**CITY OF NAPOLEON  
BUILDING CONSTRUCTION PERMIT  
(1, 2 or 3 Family Dwelling)**

FIELD CORRECTION NOTICE

DATE	Dec. 2, 1975		JOB NO.	438-75
PROJECT	New Single Family Dwelling			
LOCATION	1215 Glenwood Ave, Lot 1			
CONTRACTOR	Multi-Form	OWNER	Multi-Form	
WEATHER	_____		TEMP	° at _____ AM ° at _____ PM
CITY OF NAPOLEON ENGINEERING DEPT. PLAN APPROVAL BY <u>P.W.P.</u> DATE: <u>12/2/75</u>

TO Multi-Form  
R.R. # 4  
Napoleon, Ohio, 43545  
Addendum To Plan Approval

700

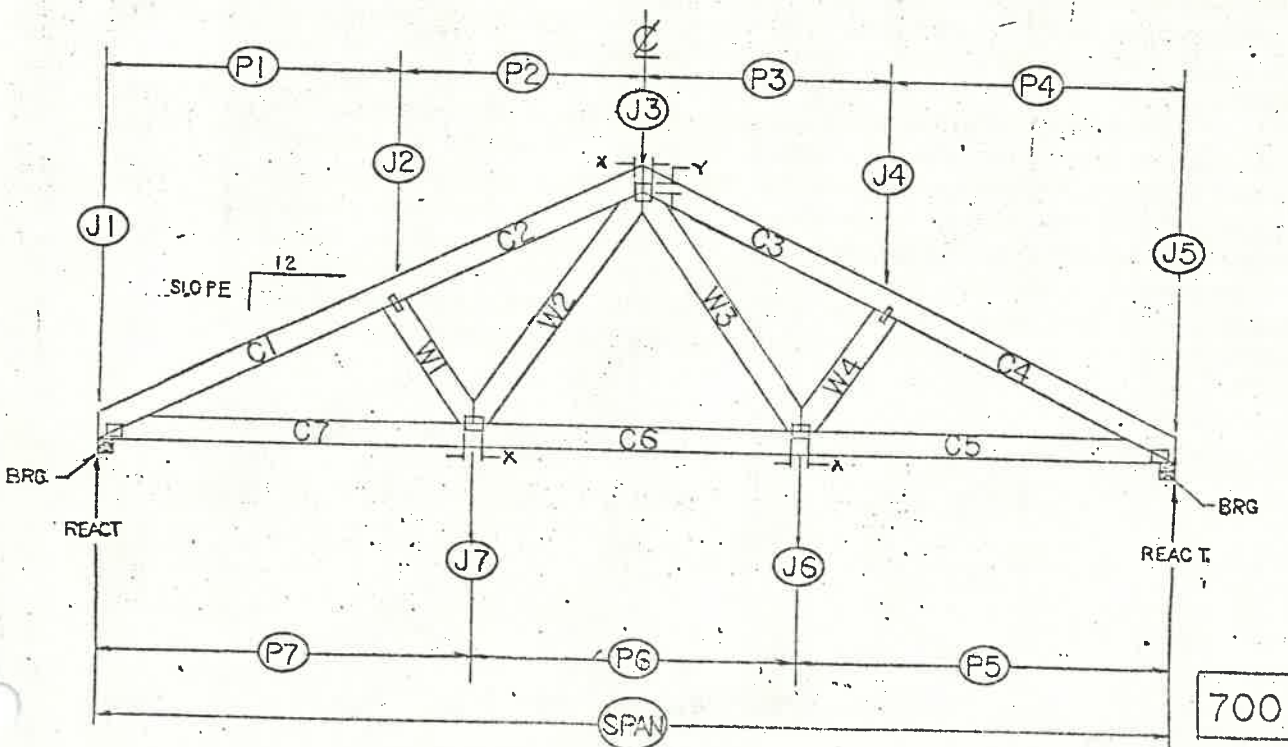
- 4) Provide min. of 0.49 sq in. net free area of ventilation for crawl space area. 507-3.
- 5) Submit two copies of thrust truss specs with an Architect or Engineer's stamp prior to installation of truss. Received 12/23/75 P.W.P.

CITY OF NAPOLEON  
ENGINEERING DEPT.  
PLAN APPROVAL  
BY: [Signature] DATE: 12/23/75
